**ADDENDUM NUMBER 02**

**Project No. 22009 / 23007**  
**Sandusky County EMS**  
**Life Squad Station 14 / SCEMS Administrative Offices & Life Squad Station 18**

This Addendum supplements and amends the original Drawings and Specifications dated **October 24, 2024**, and shall be taken into account in preparing bids and becomes a part of the contract documents. Note: this addendum information is issued to bidders of record. It is the prime contractor's responsibility to forward this Addendum information to all affected suppliers and sub/contractors and make adjustments relative to the proposal. Bidders should acknowledge receipt of Addendum on Page BF-1 of the Bid Form, or the last page of this Addendum.

**1 ENLARGED MECHANICAL YARD PLAN**  
A1.1 1/4"=1'-0"

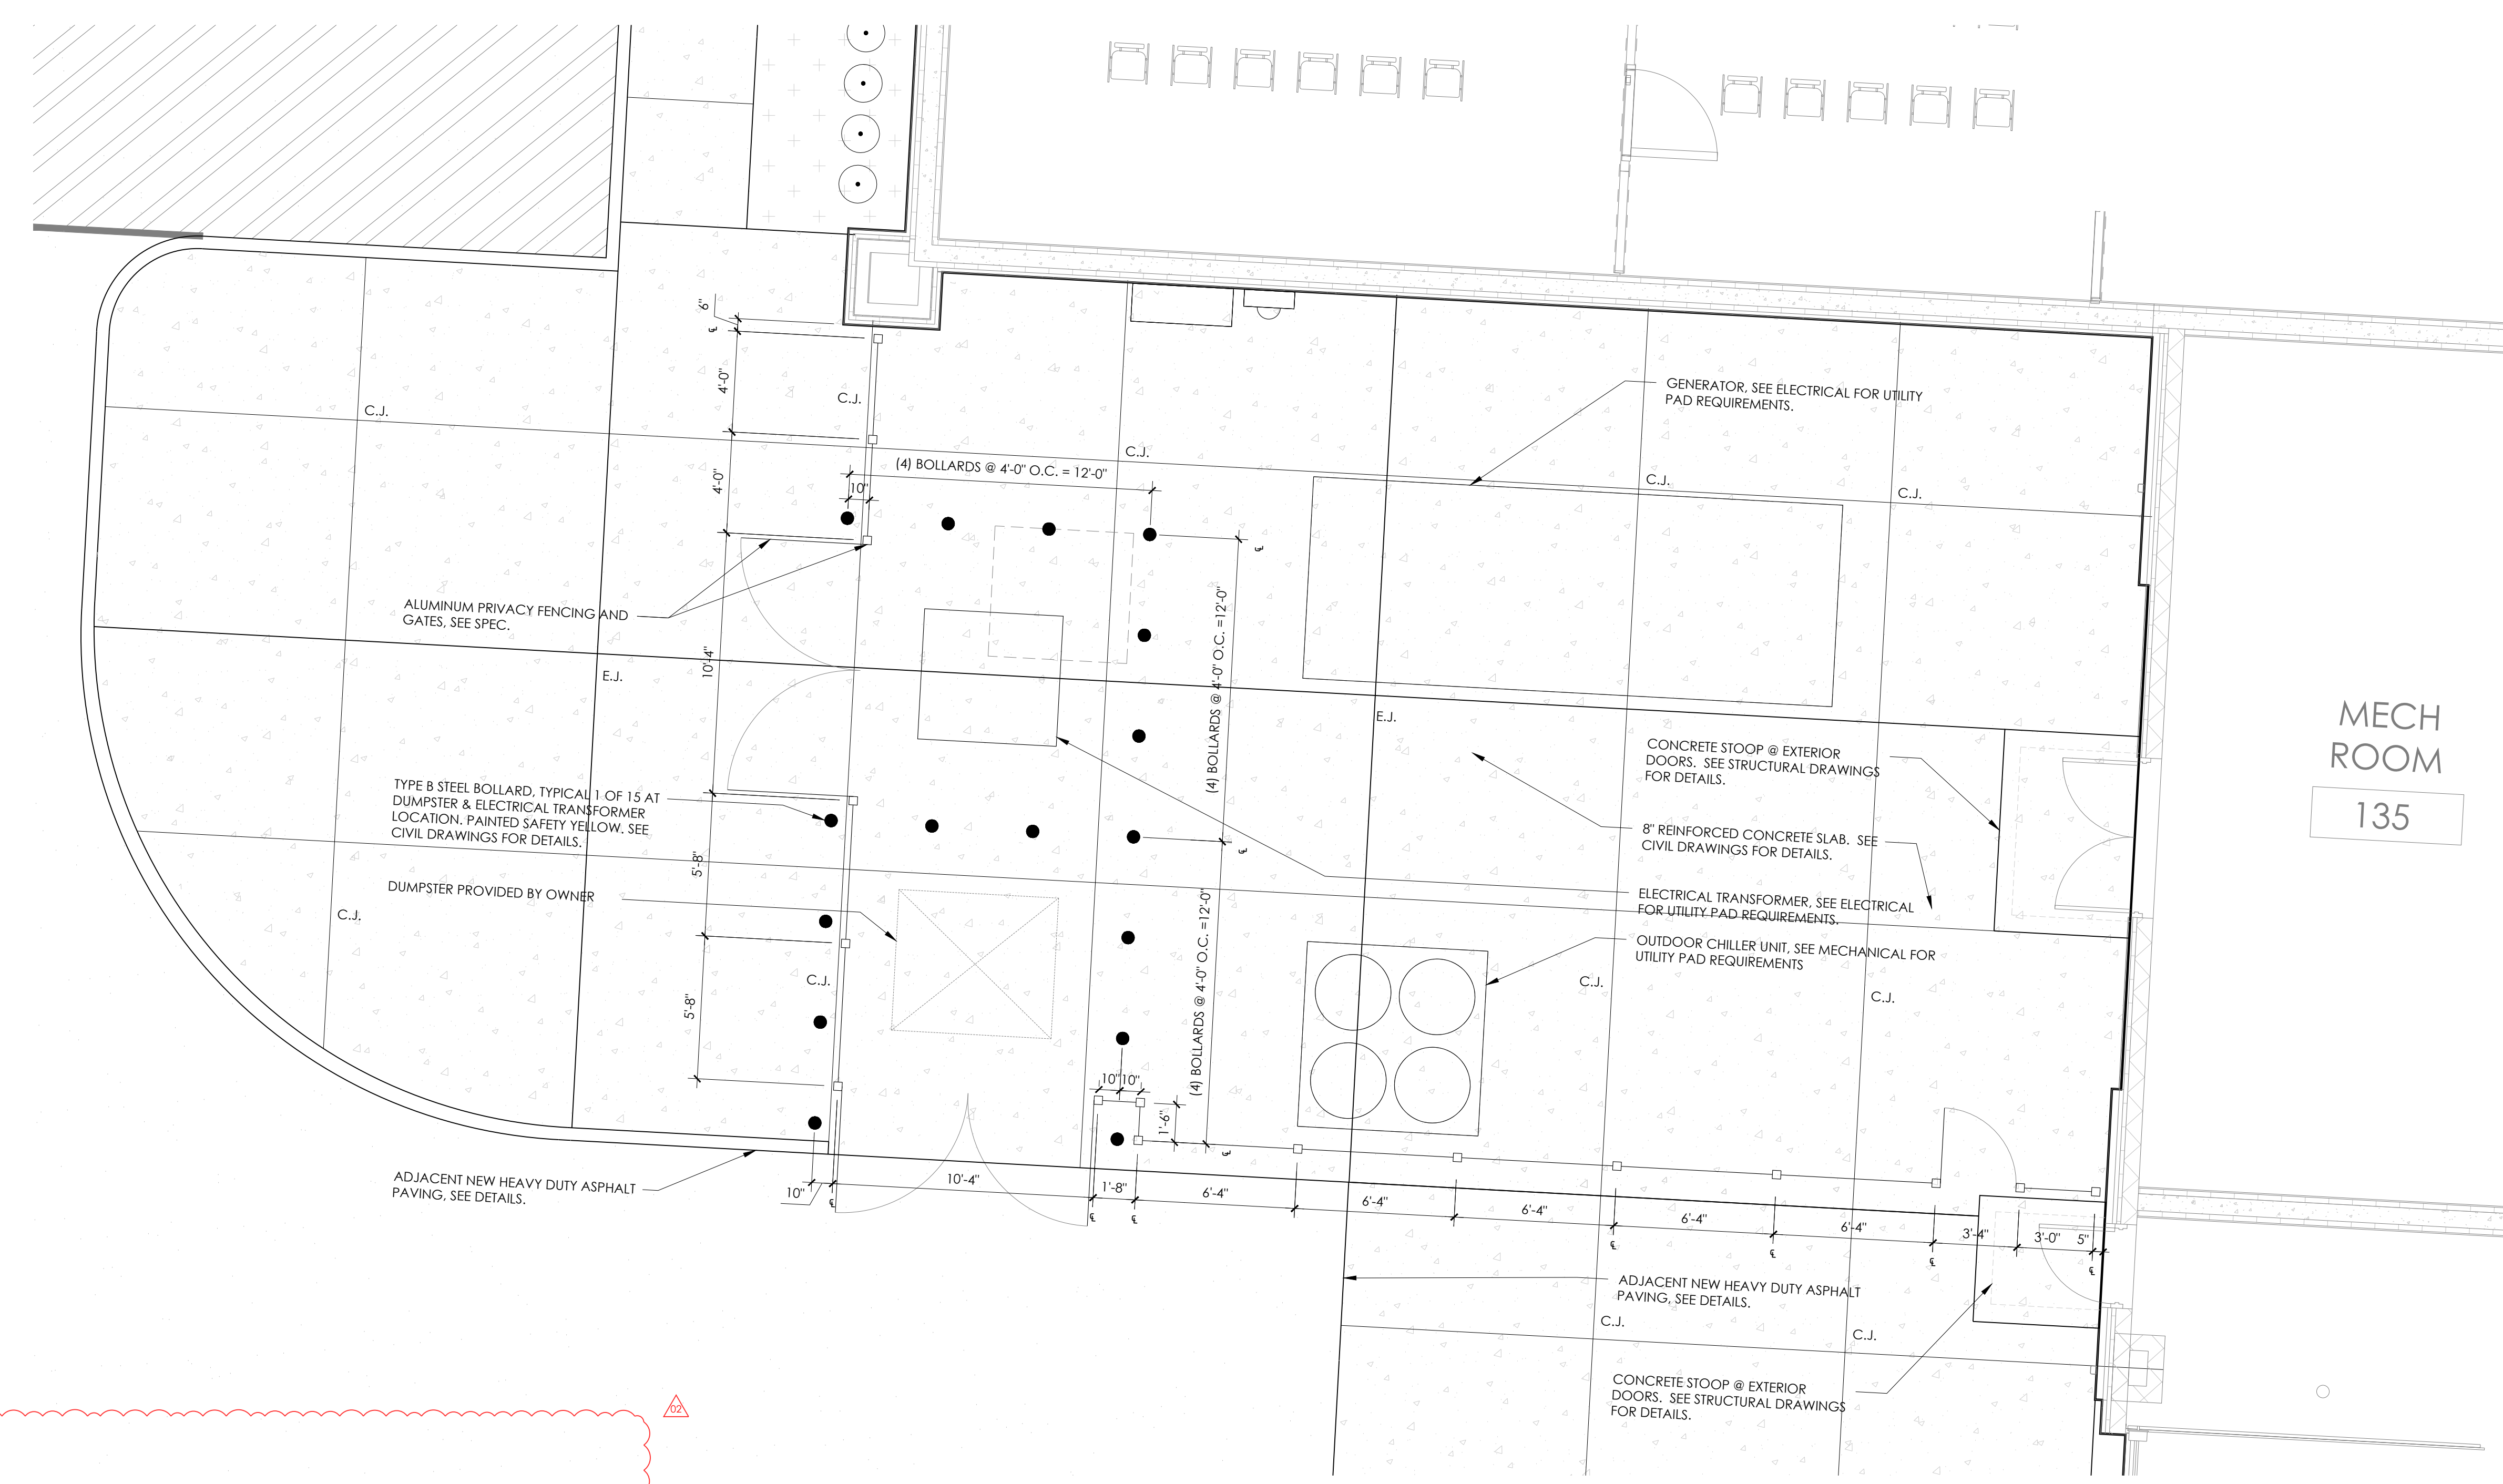
2. **A1.1 (REISSUED)**
  - a. **Plan 1/A1.1:** Layout of the mechanical yard has been revised.
3. **C1.0 (REISSUED)**
  - a. Storm Pipe Removal Note added to clarify the intent and extents of pipe removal on site. The note also directs the bidder to provide unit pricing for pipe removal.

BID DRAWINGS  
DRAWING NUMBER:  
**C1.0**

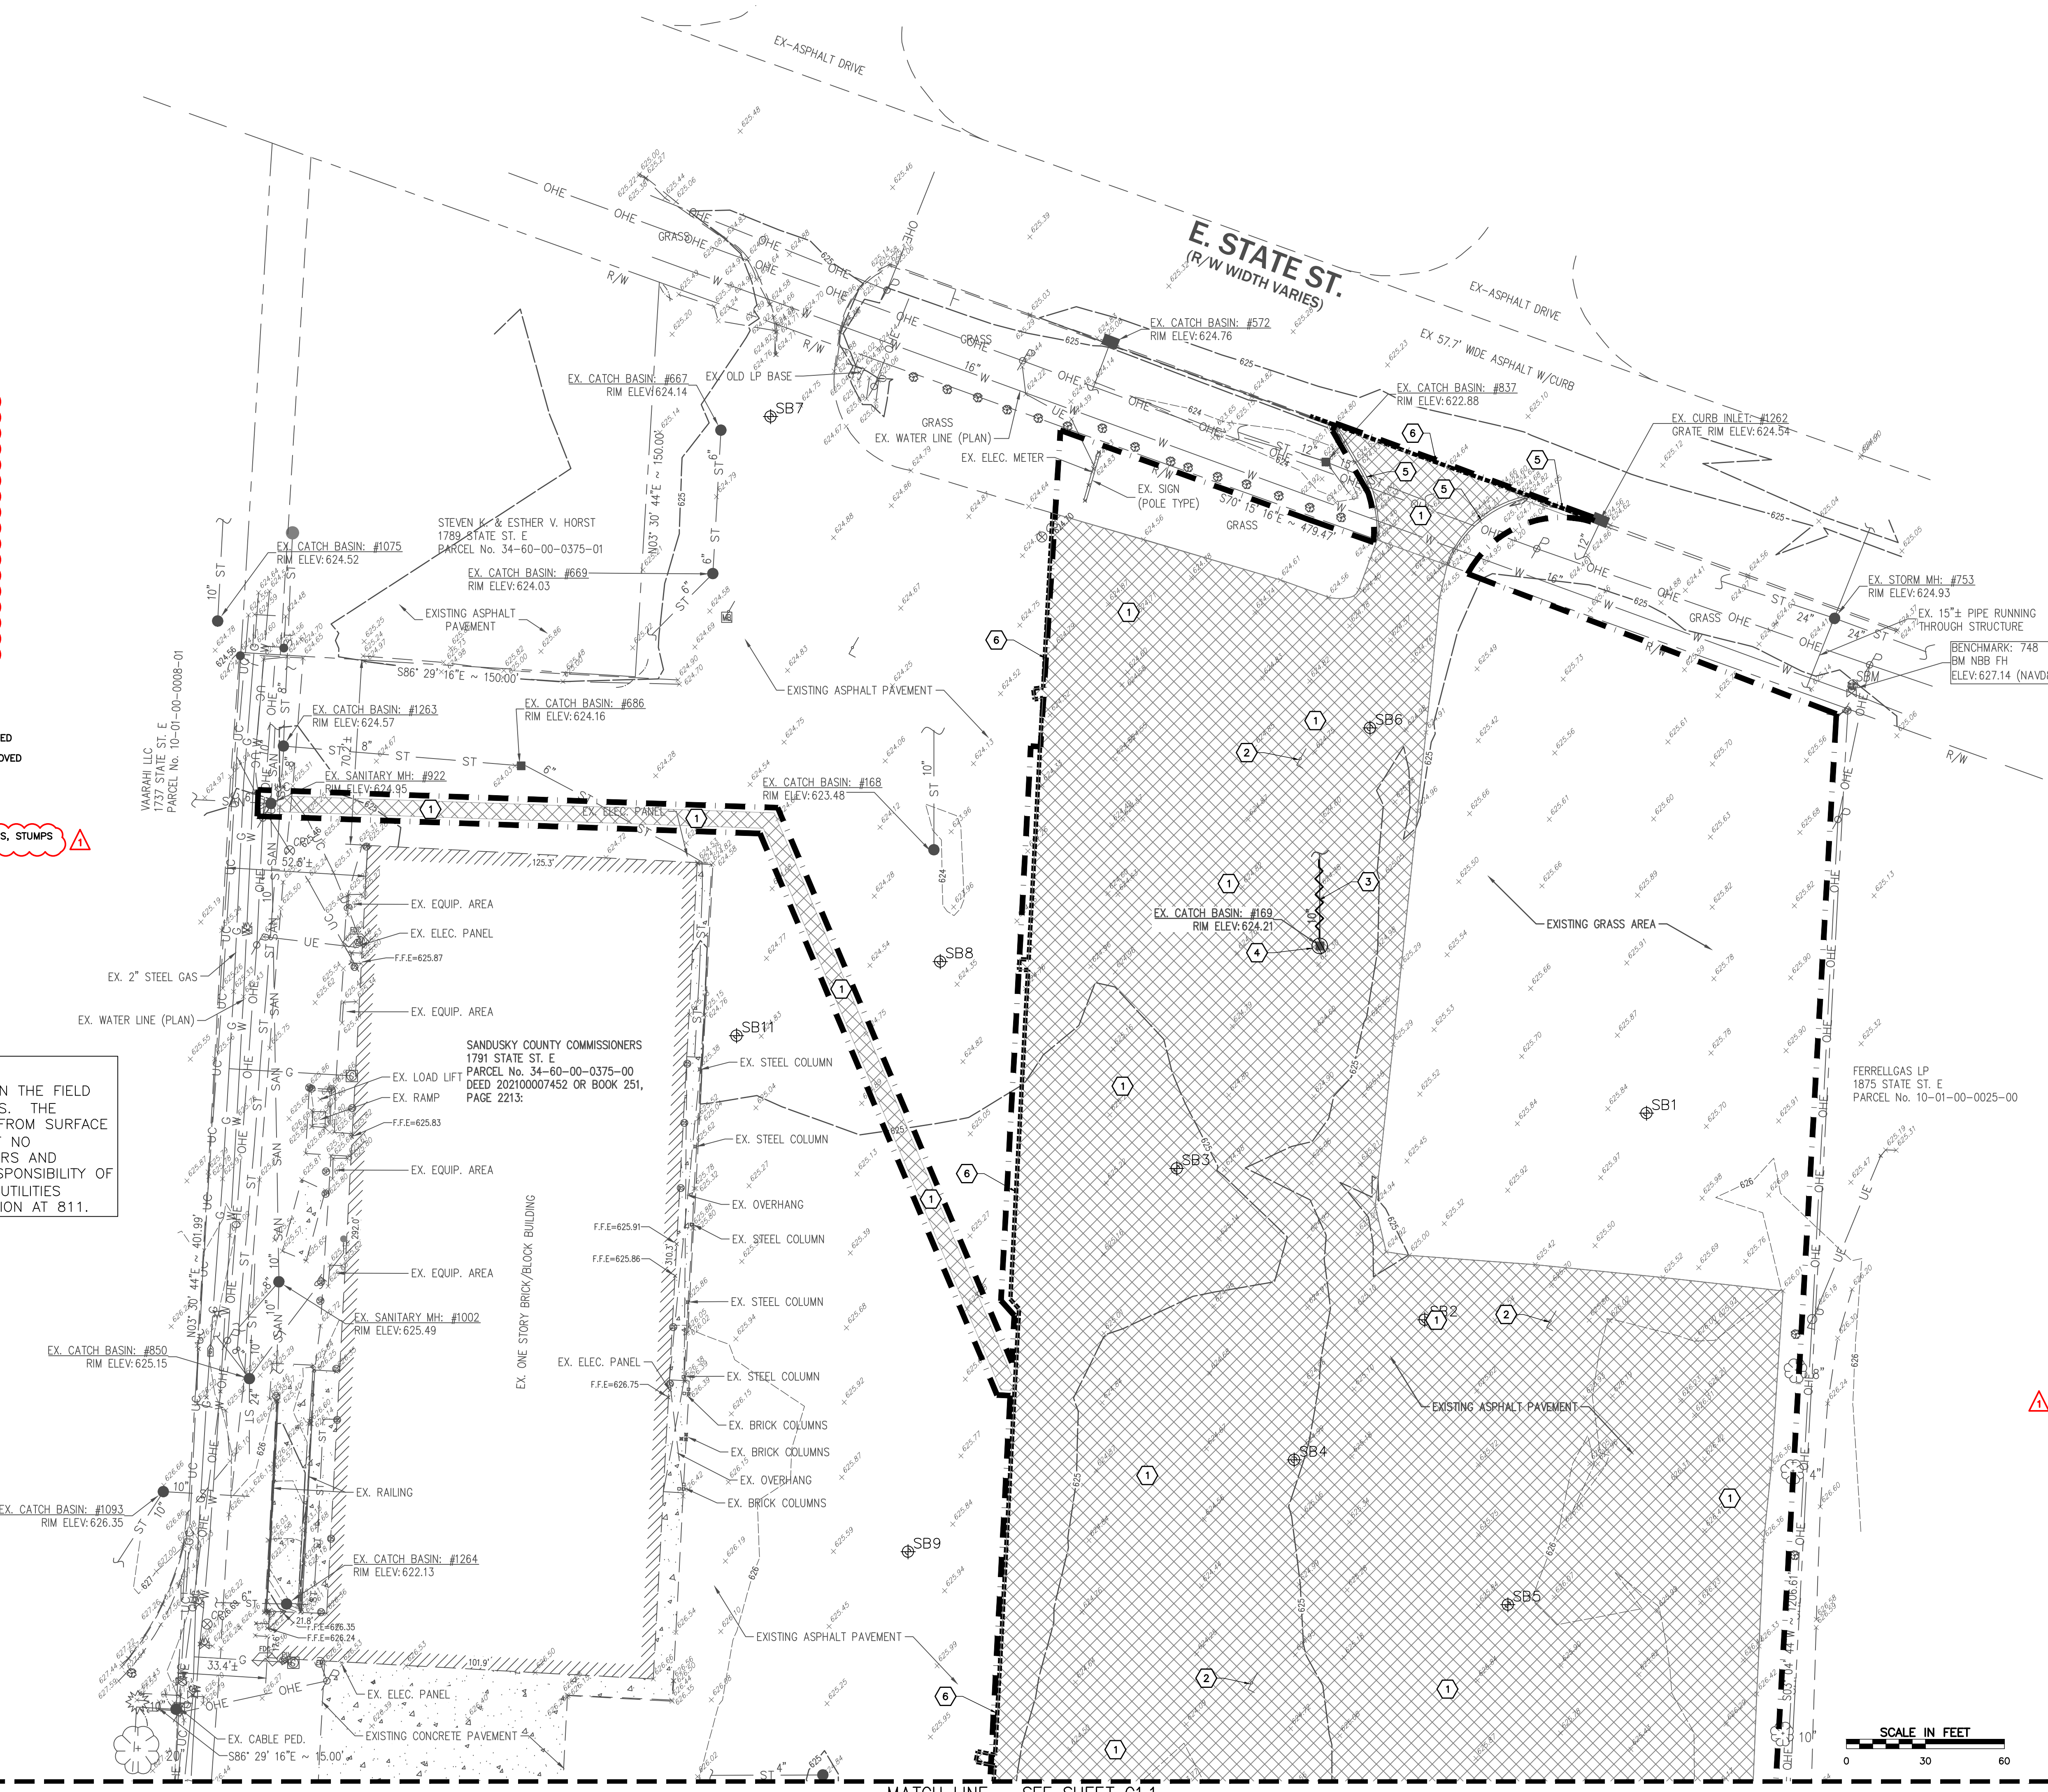
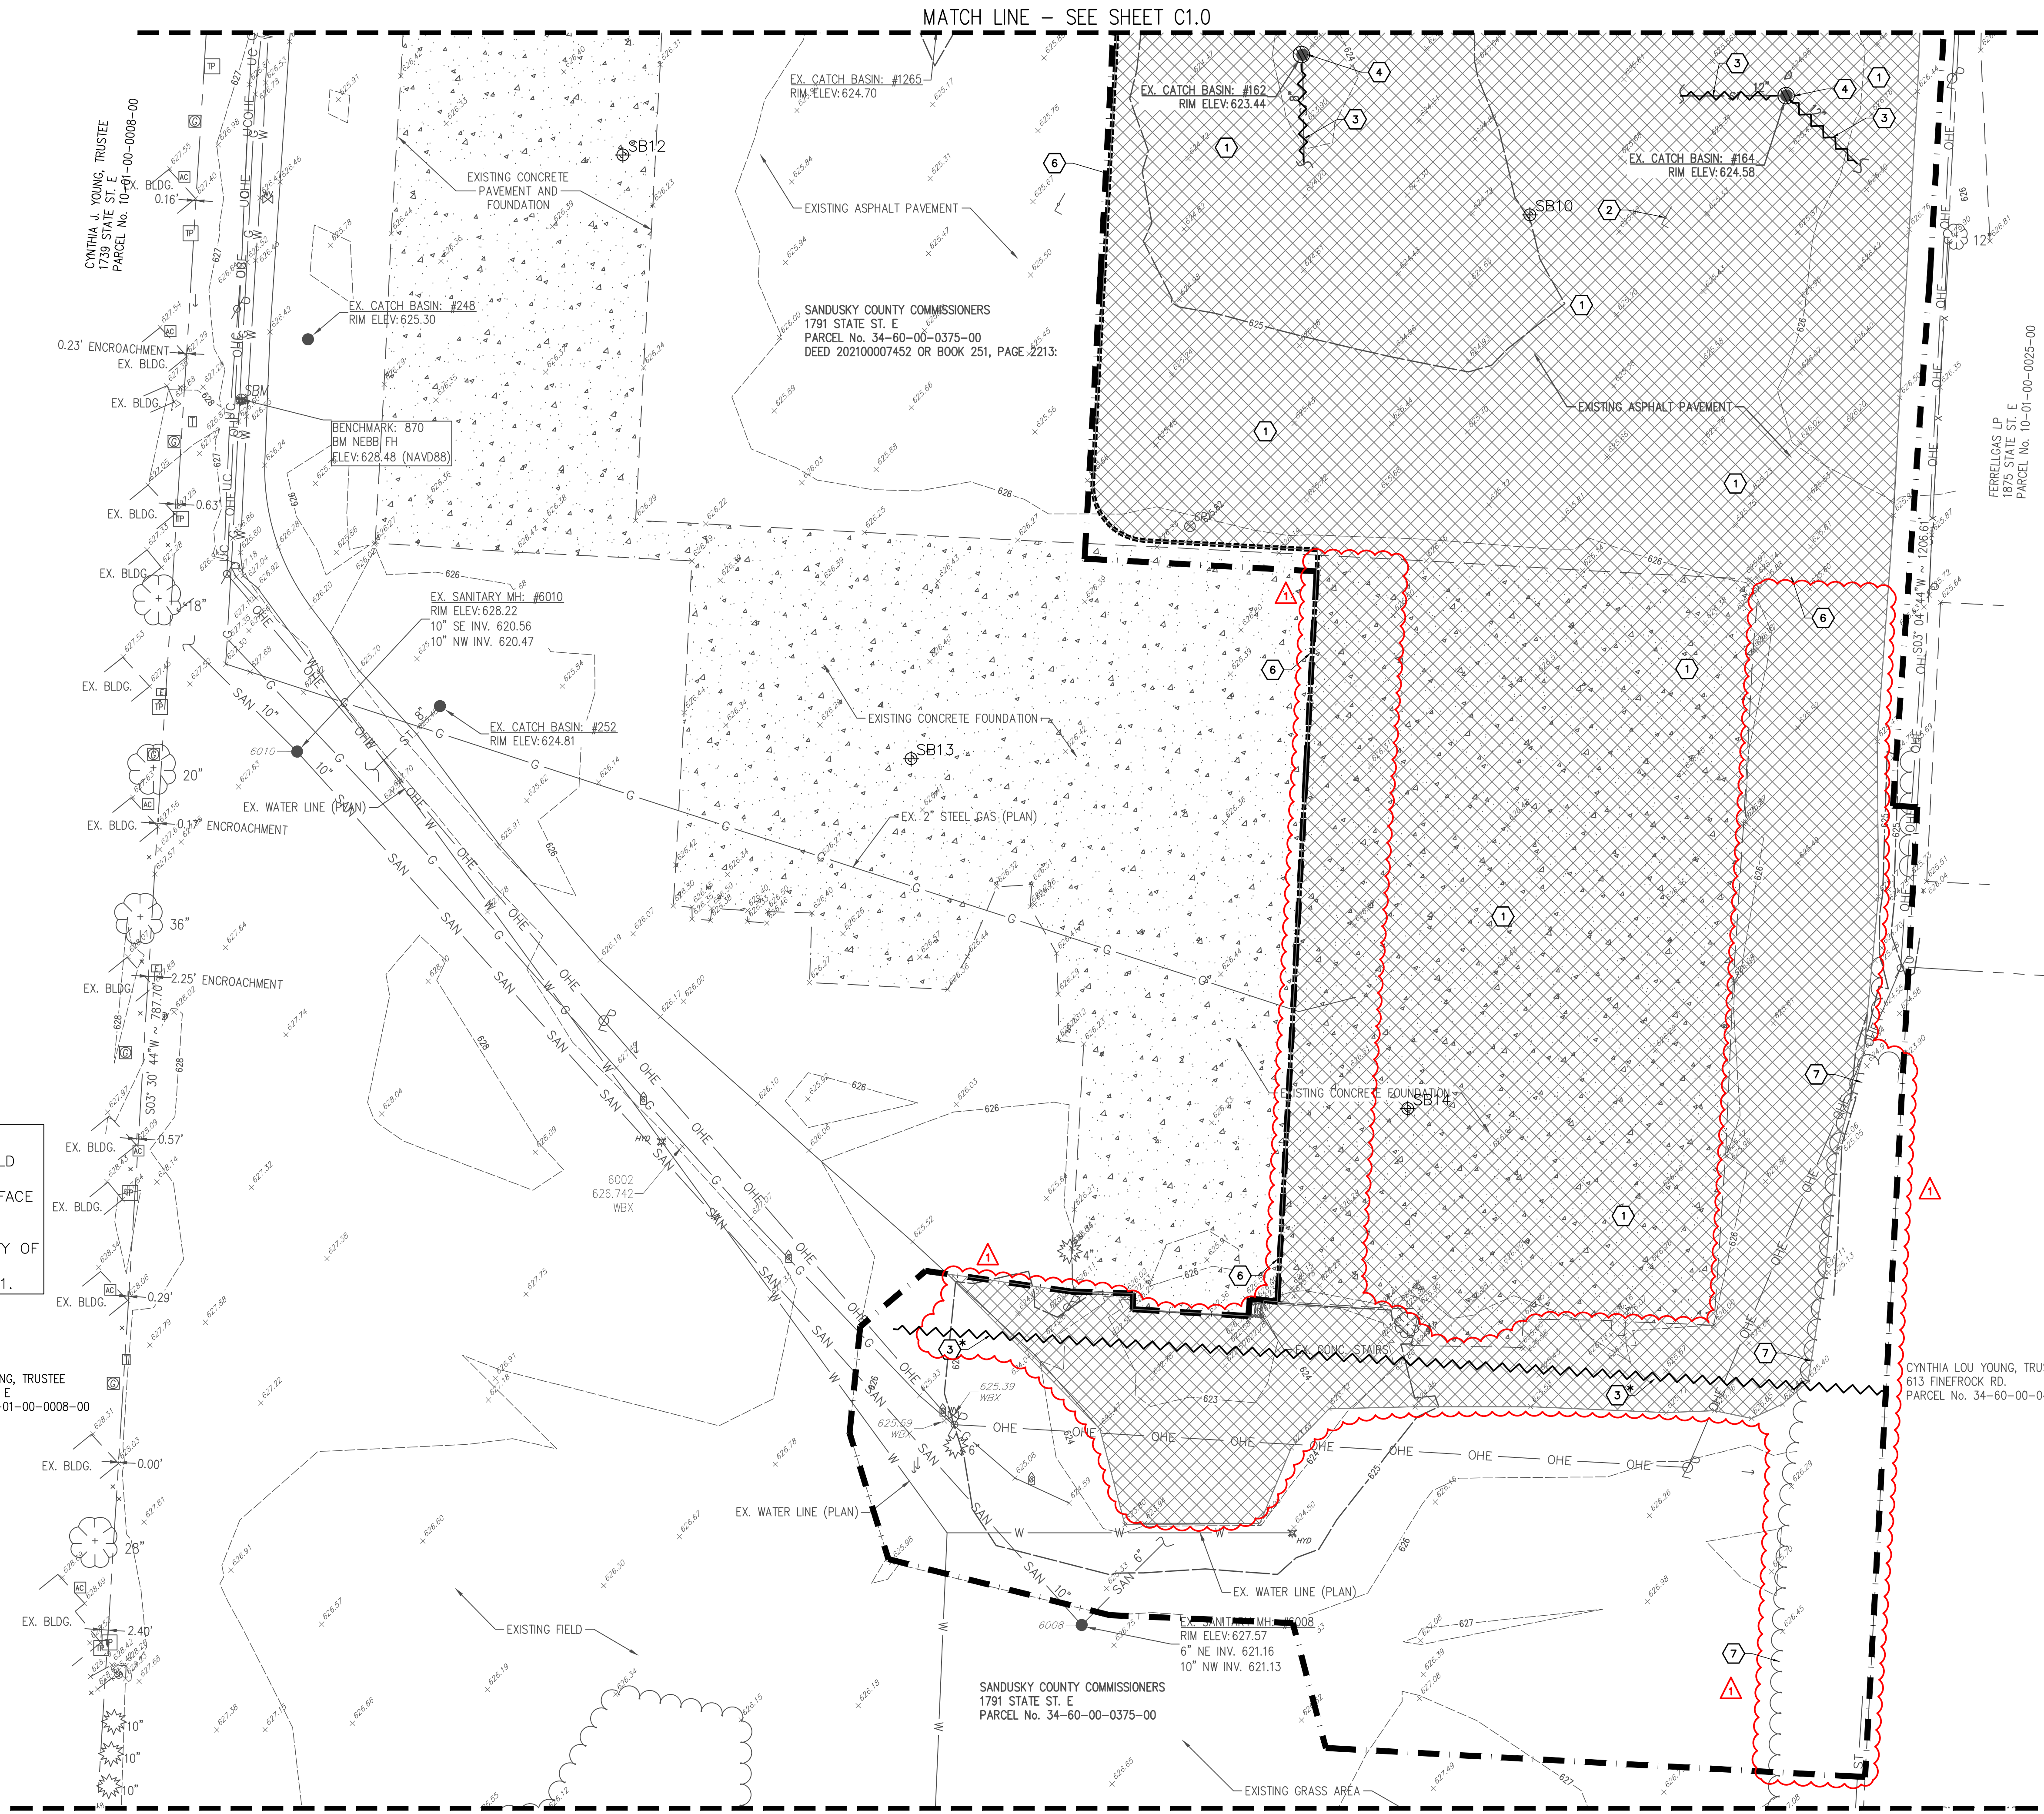
- b. An additional note has also been added to direct the bidder to
  - c. Clearing and grubbing has been added to the Site Plan Demolition Legend
4. **C1.1 (REISSUED)**
